AMENDMENT NO. 1 APRIL 2016
TO
IS 875 (PART 3) : 2015 DESIGN LOADS (OTHER THAN EARTHQUAKE) FOR
BUILDINGS AND STRUCTURES — CODE OF PRACTICE

PART 3 WIND LOADS

(Third Revision)

(Page 14, Table 6, bottommost figure) — Substitute the following figure for the existing:

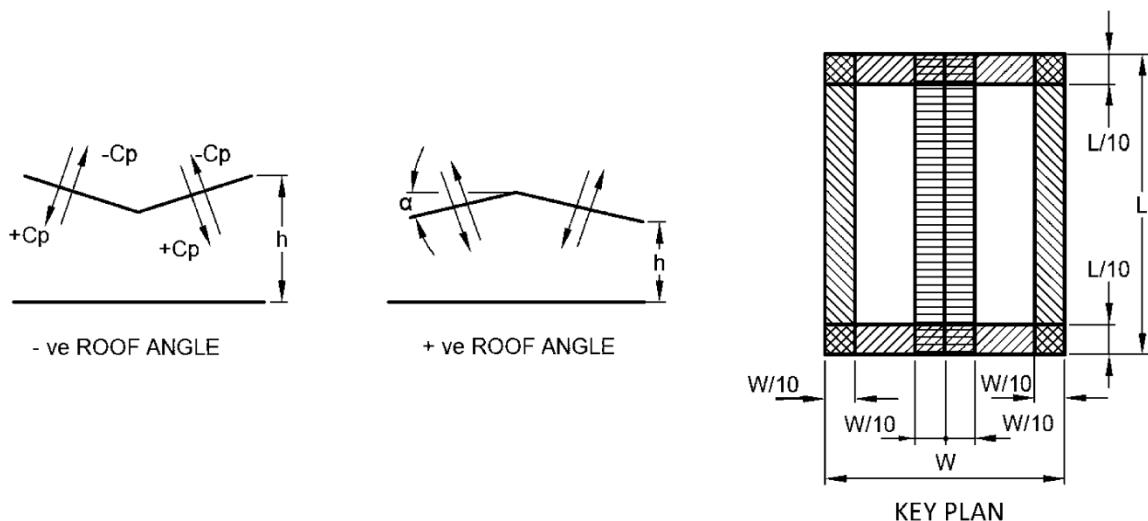
$y = h$ or $0.15 w$ whichever is the lesser.

Table 18 External Pressure Coefficients (C_{pe}) for Curved Roofs
(Clause 7.3.3.6)

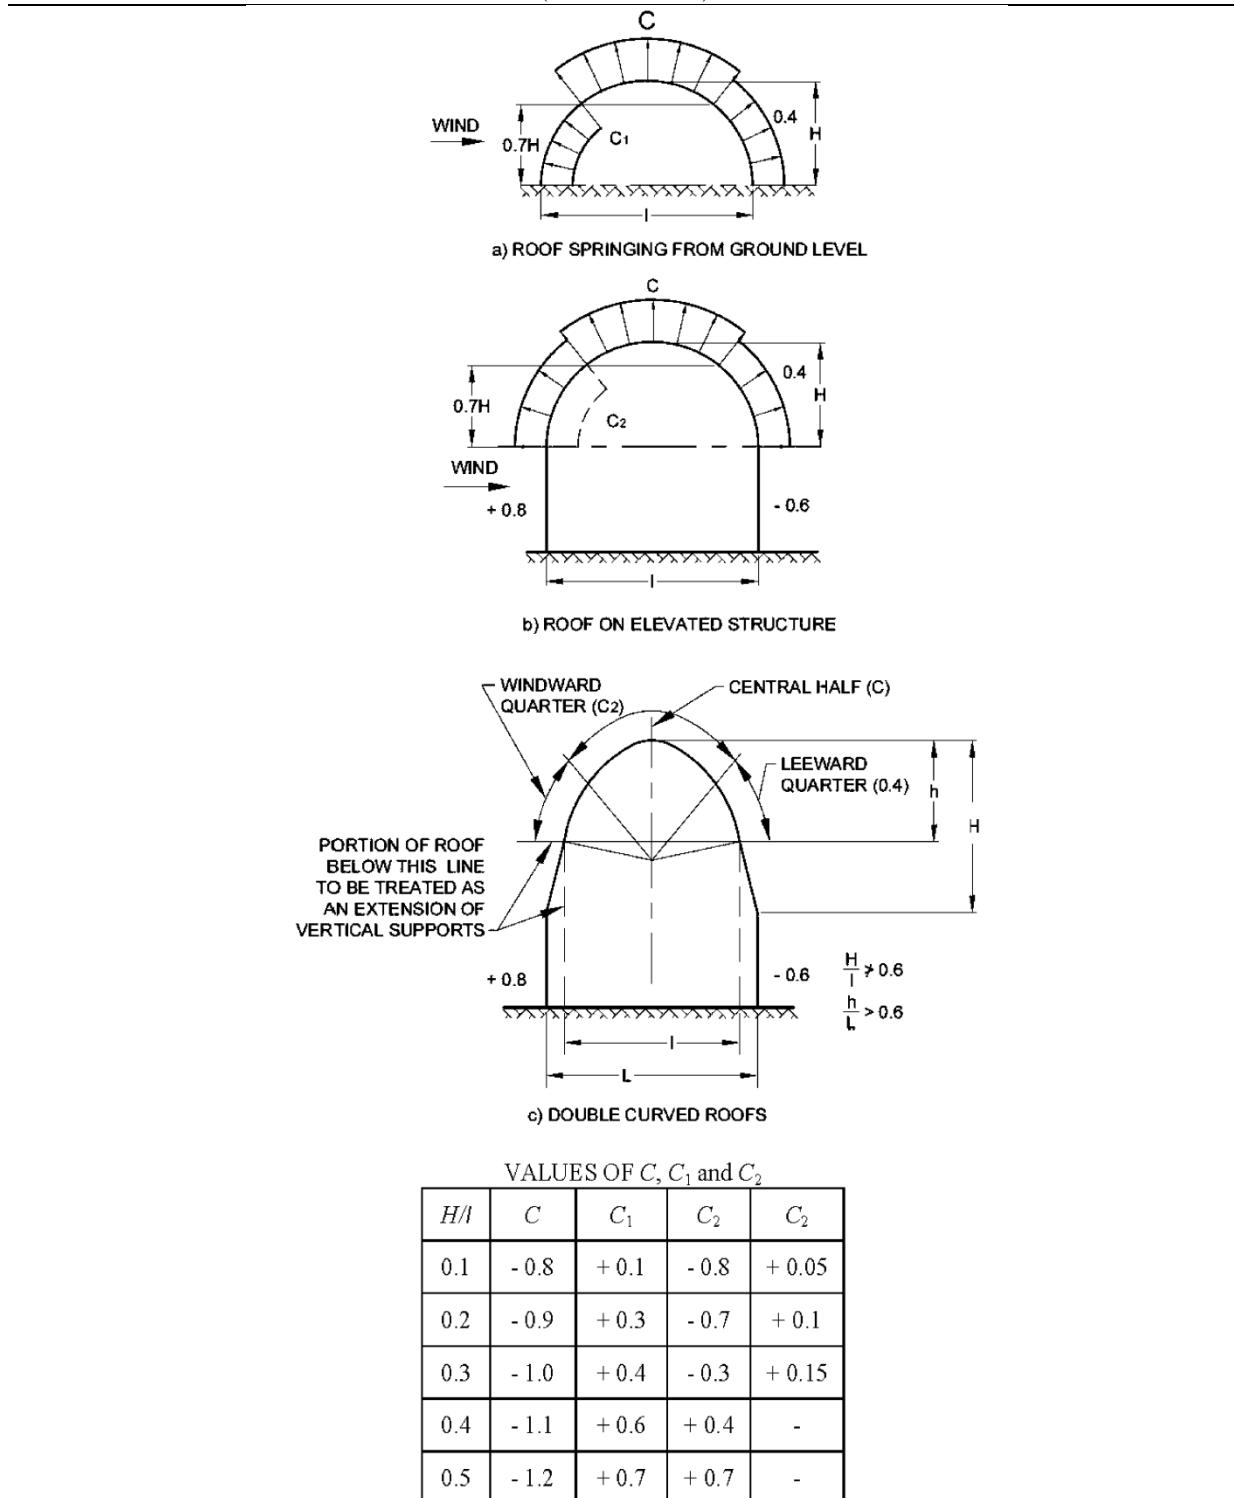
(Page 27, Table 18) — Substitute the following for the existing table:

NOTE: When the wind is blowing normal to gable ends, C_{pe} may be taken as equal to -0.7 for the full width of the roof over a length of $I/2$ from the gable ends and -0.5 for the remaining portion.
